## Wisconsin Department of Transportation

**Proposal #19: 6180-30-71, WISC 2026038**  
**Omro - Oshkosh**  
**STH 116 – Leonard Point Road**  
**STH 21**  
**Winnebago County**

This is Addendum No. 01, which provides for the following:

**ADDENDUM NO. 01**  
**6180-30-71, 6180-30-72, 6180-30-73, 6180-31-71**  
**November 4, 2025**

Addendum No. 01  
ID 6180-30-71  
Revised Sheet 124  
November 4, 2025

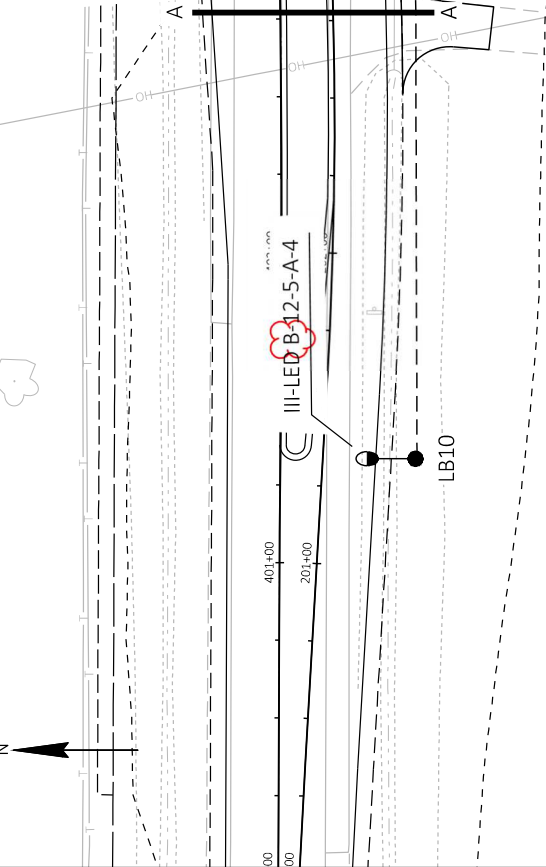
| <b>Revised Plan Sheets – Project ID 6180-30-71/72/73</b> |                                                                                                                                                     |
|----------------------------------------------------------|-----------------------------------------------------------------------------------------------------------------------------------------------------|
| 124                                                      | Construction Detail – Roundabout Lighting (CTH FF) (changed LED from A to B)                                                                        |

Addendum No. 01  
ID 6180-30-71  
Revised Sheet 126  
November 4, 2025

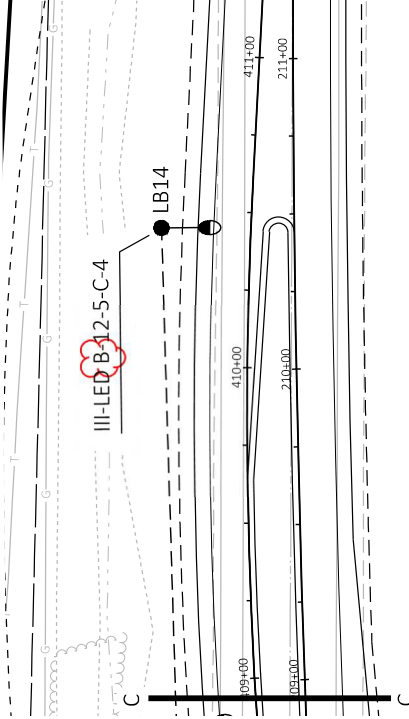
| <b>Revised Plan Sheets – Project ID 6180-30-71/72/73</b> |                                                                                                                                                     |
|----------------------------------------------------------|-----------------------------------------------------------------------------------------------------------------------------------------------------|
| 126                                                      | Construction Detail – Roundabout Lighting (CTH FF) (changed LED from A to B)                                                                        |

Addendum No. 01  
ID 6180-30-71  
Revised Sheet 127  
November 4, 2025

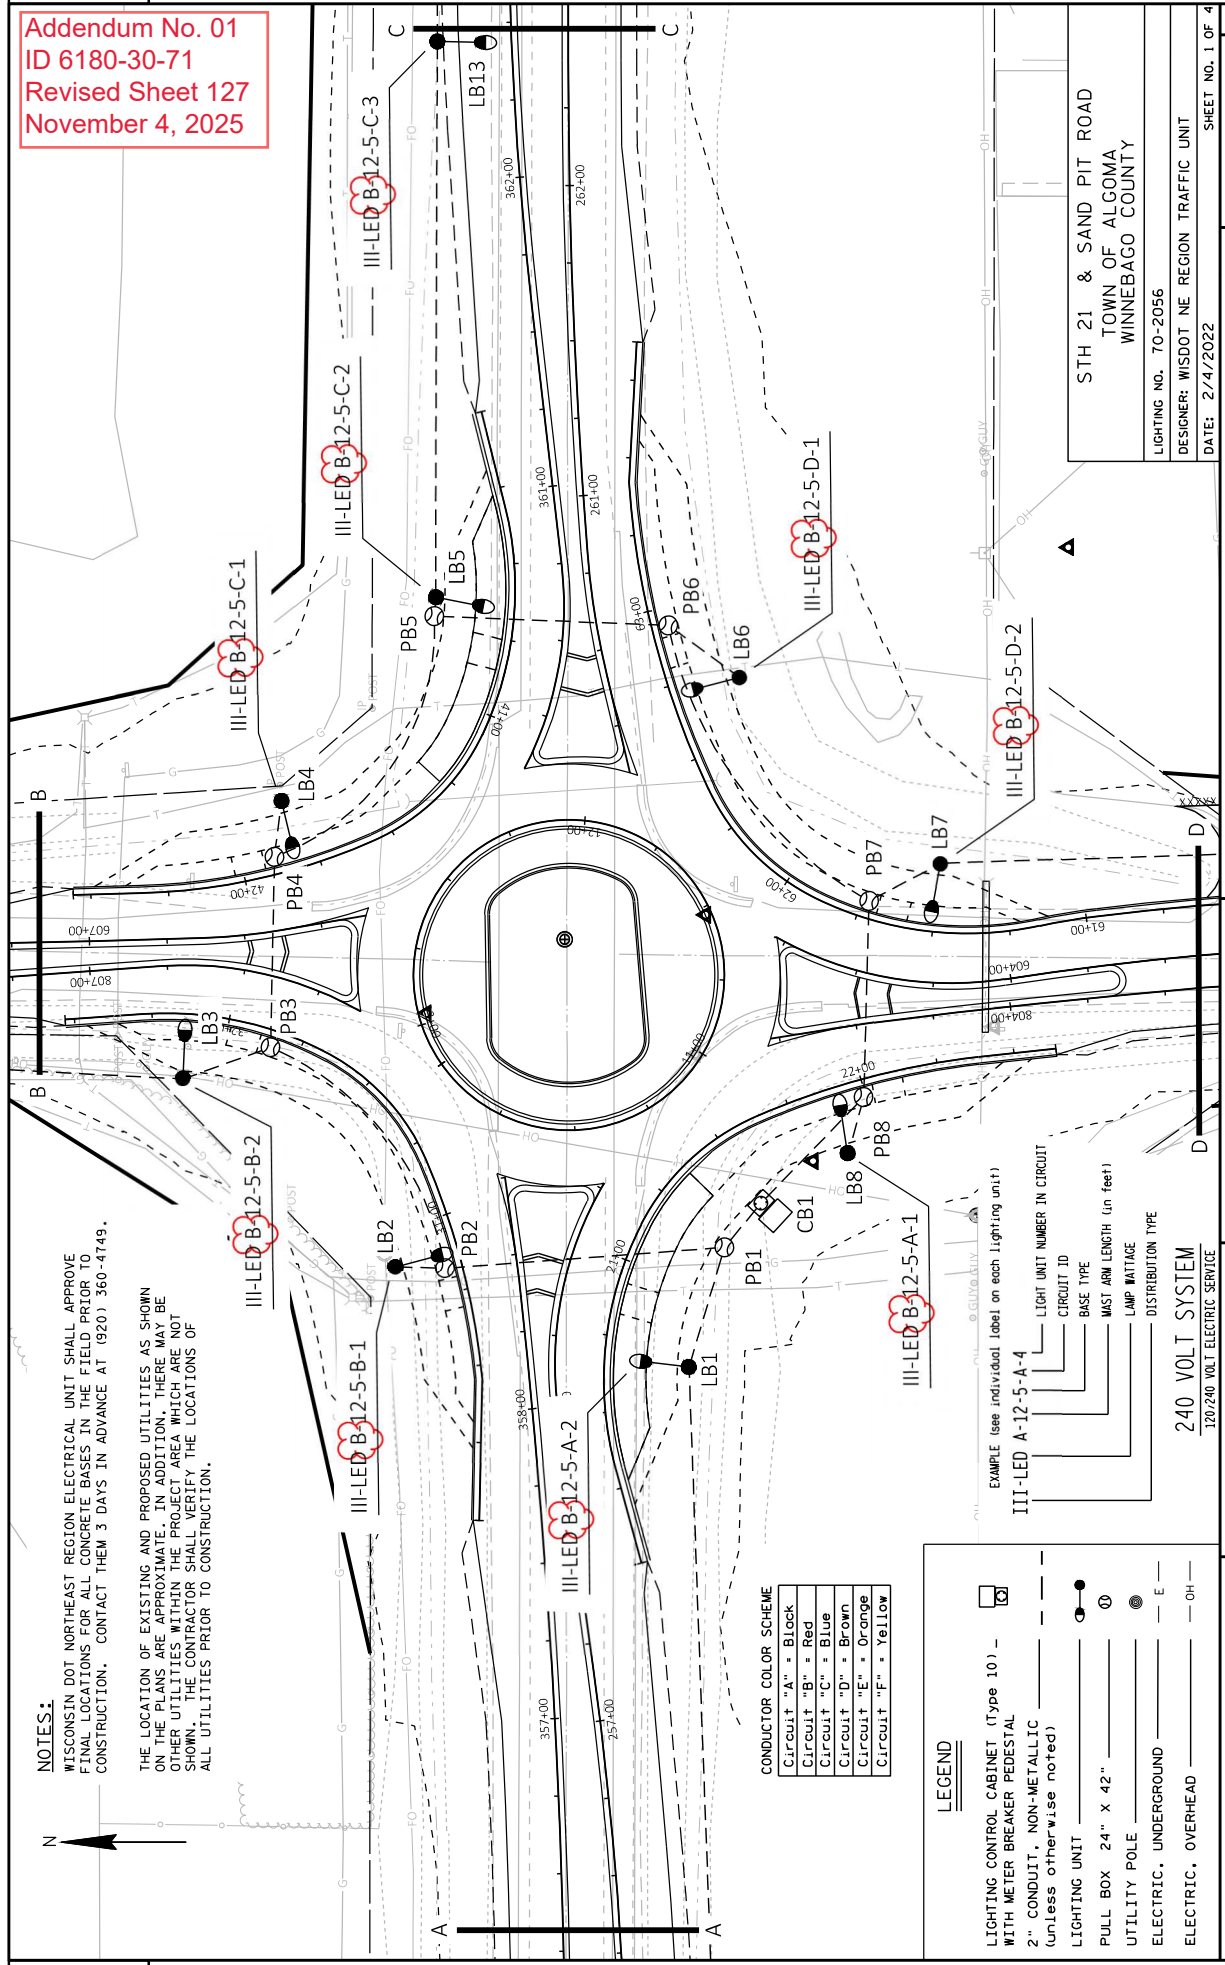
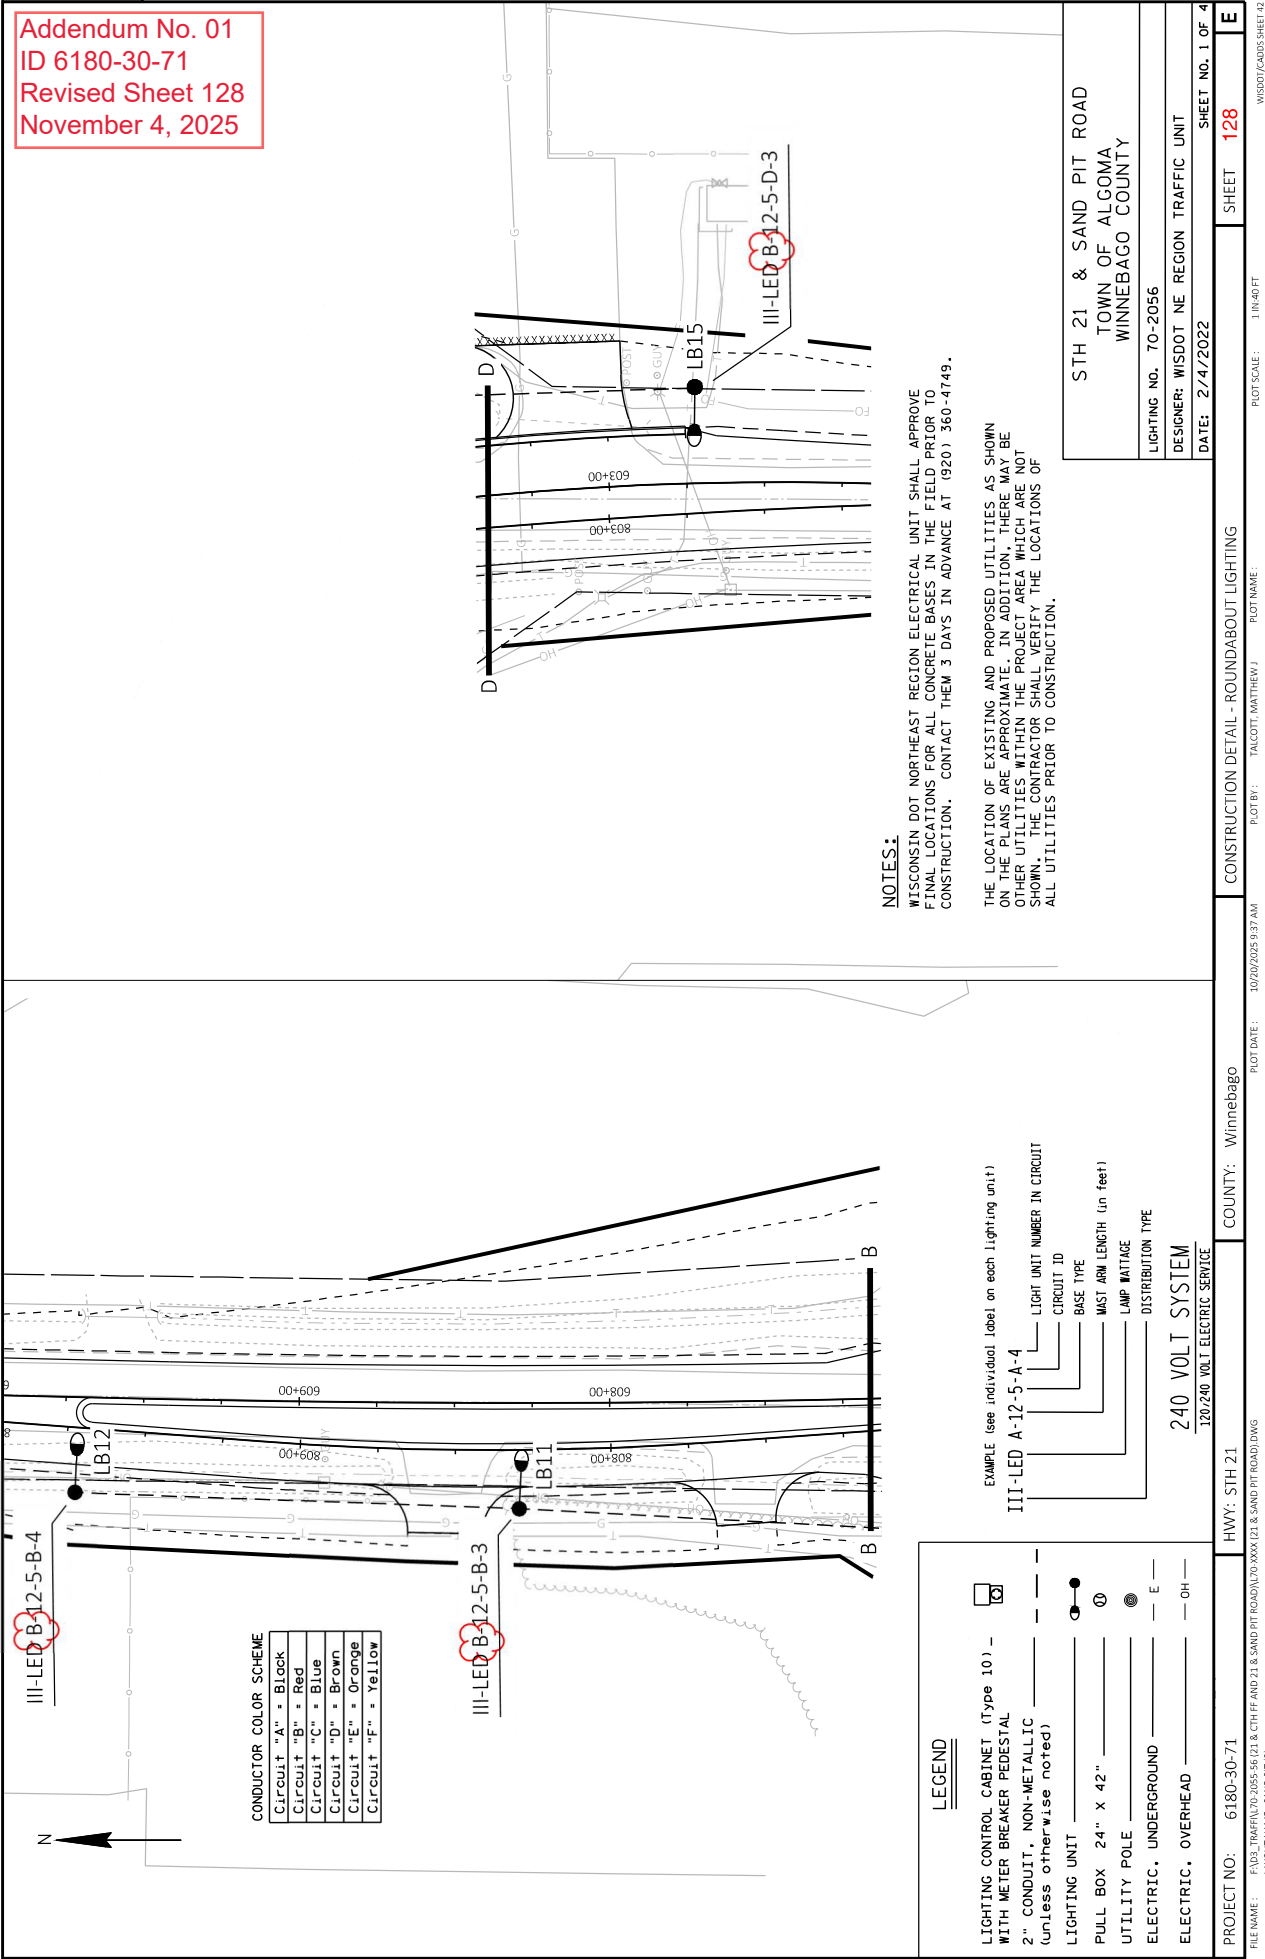
| <b>Revised Plan Sheets – Project ID 6180-30-71/72/73</b> |                                                                                                                                                     |
|----------------------------------------------------------|-----------------------------------------------------------------------------------------------------------------------------------------------------|
| 127                                                      | Construction Detail – Roundabout Lighting (Sand Pit Rd) (changed LED from A to B)                                                                   |

Addendum No. 01  
ID 6180-30-71  
Revised Sheet 128  
November 4, 2025

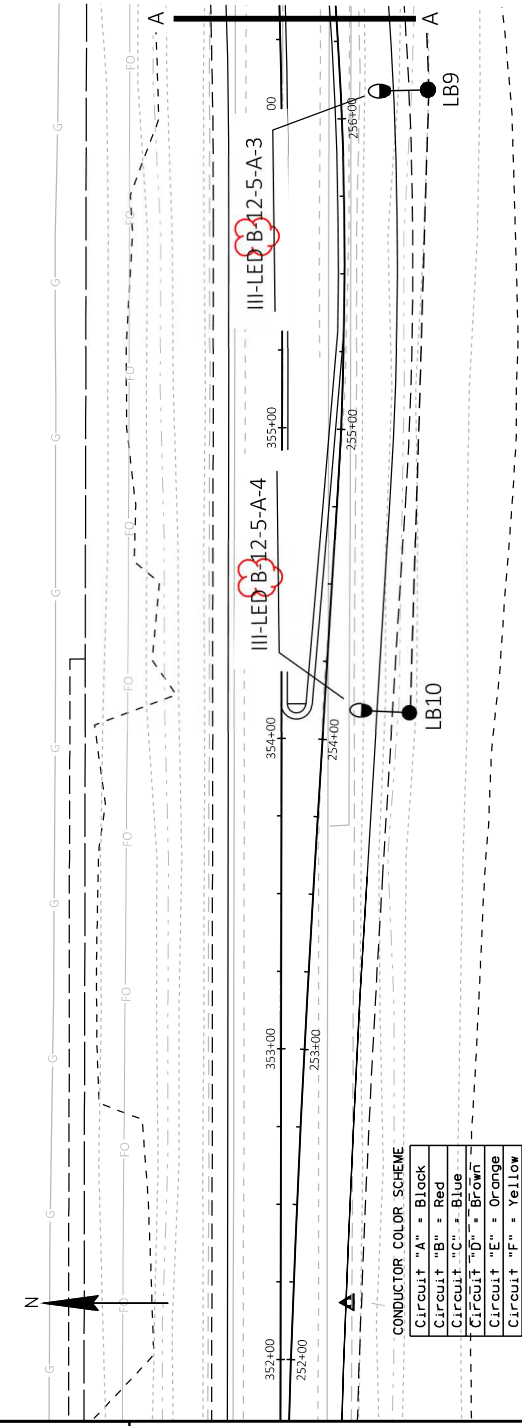
| <b>Revised Plan Sheets – Project ID 6180-30-71/72/73</b> |                                                                                                                                                     |
|----------------------------------------------------------|-----------------------------------------------------------------------------------------------------------------------------------------------------|
| 128                                                      | Construction Detail – Roundabout Lighting (Sand Pit Rd) (changed LED from A to B)                                                                   |

Addendum No. 01  
ID 6180-30-71  
Revised Sheet 129  
November 4, 2025

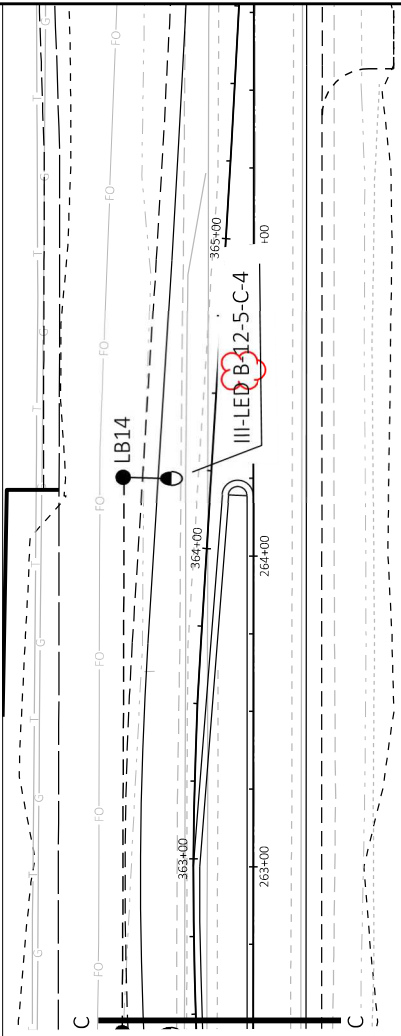
| <b>Revised Plan Sheets – Project ID 6180-30-71/72/73</b> |                                                                                                                                                     |
|----------------------------------------------------------|-----------------------------------------------------------------------------------------------------------------------------------------------------|
| 129                                                      | Construction Detail – Roundabout Lighting (Sand Pit Rd) (changed LED from A to B)                                                                   |

Addendum No. 01  
ID 6180-31-71  
Revised Sheet 100  
November 4, 2025

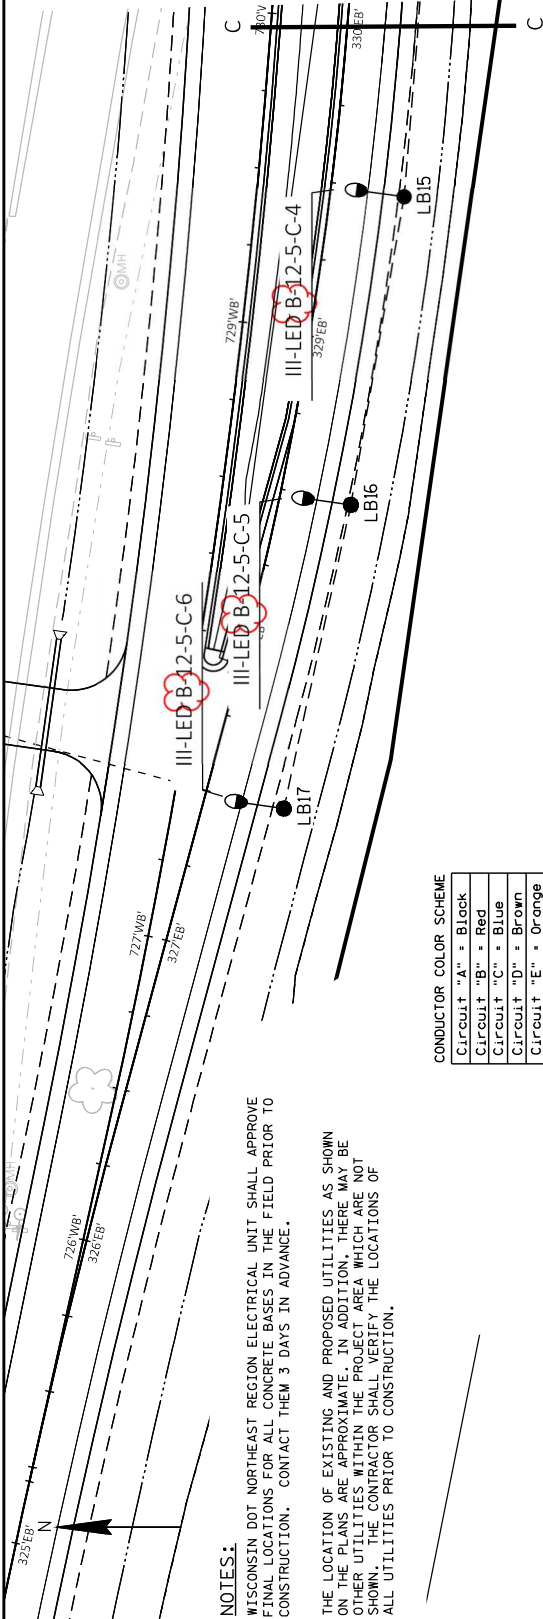
| <b>Revised Plan Sheets – Project ID 6180-31-71</b> |                                                                     |
|----------------------------------------------------|---------------------------------------------------------------------|
| 100                                                | Construction Detail – Roundabout Lighting (changed LED from A to B) |

Addendum No. 01  
ID 6180-31-71  
Revised Sheet 102  
November 4, 2025

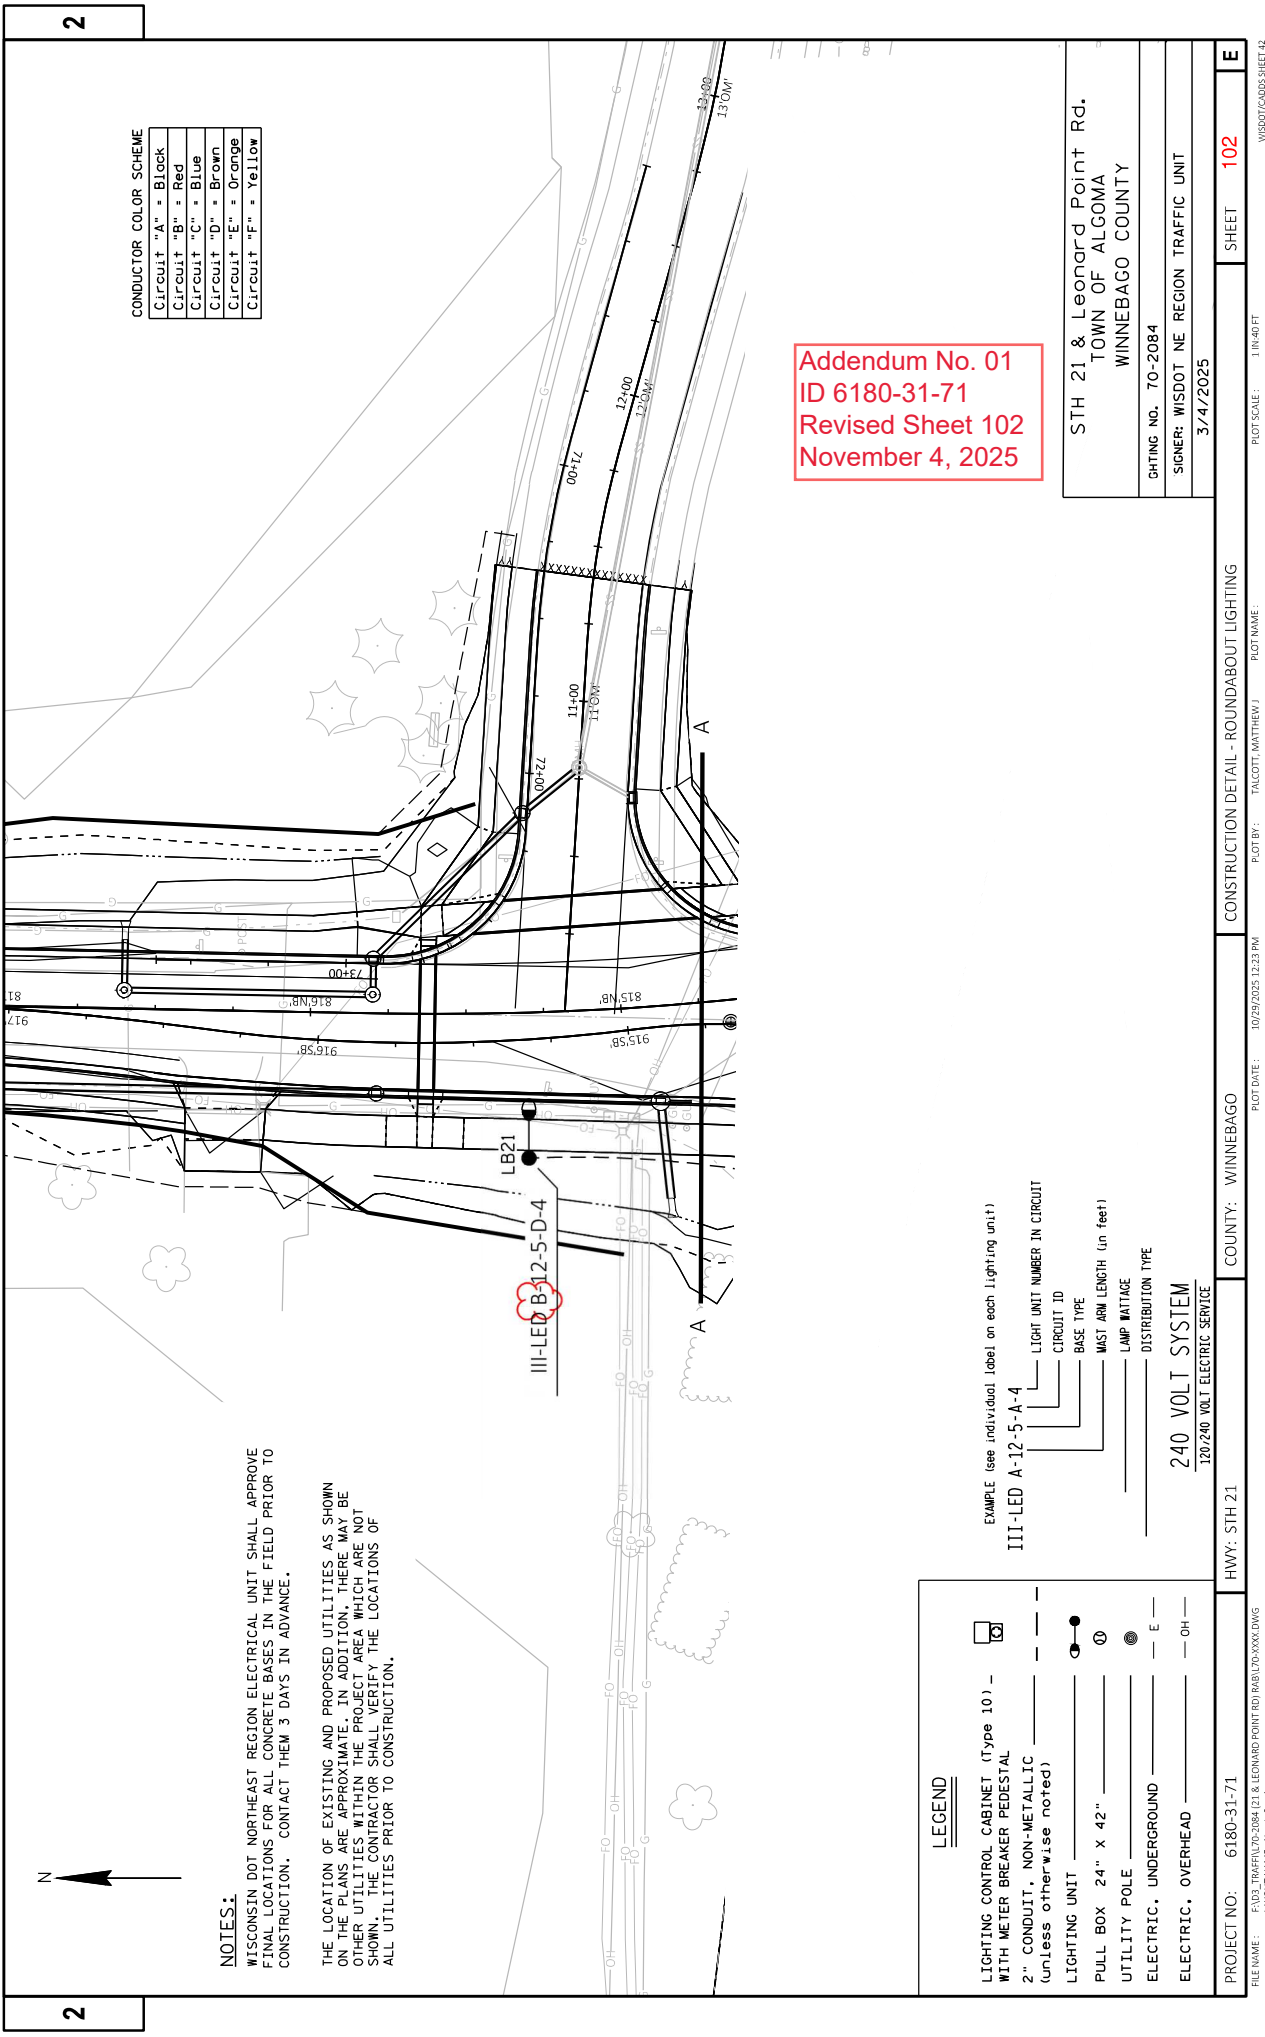
| <b>Revised Plan Sheets – Project ID 6180-31-71</b> |                                                                     |
|----------------------------------------------------|---------------------------------------------------------------------|
| 102                                                | Construction Detail – Roundabout Lighting (changed LED from A to B) |
